# WARRANTY BULLETIN

WB23-25

SUBJECT: QR CODE REPLACMENT

Model	VIN	PREVOST CAR INC.
H3-45 coaches Model Year: 2024	From 2	PCH3349XRC72 <u>1453</u> up to 2PCH33498RC72 <u>1502</u> incl.

#### **PROCEDURE**

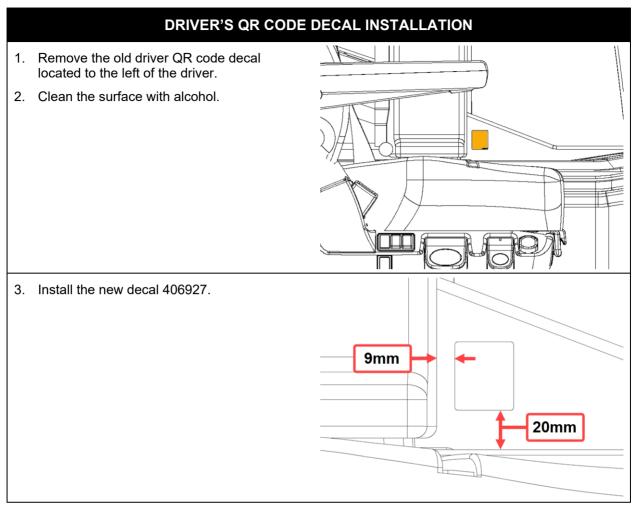
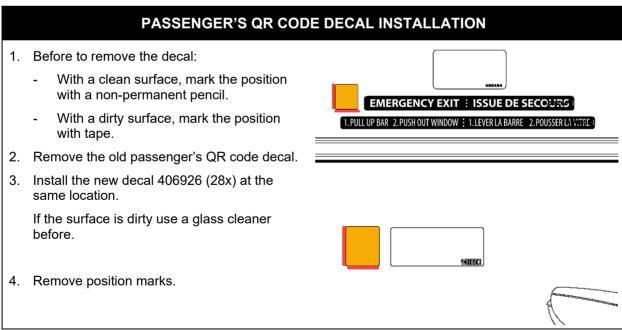
On the vehicles affected by this bulletin, replace driver's and passenger's QR code.
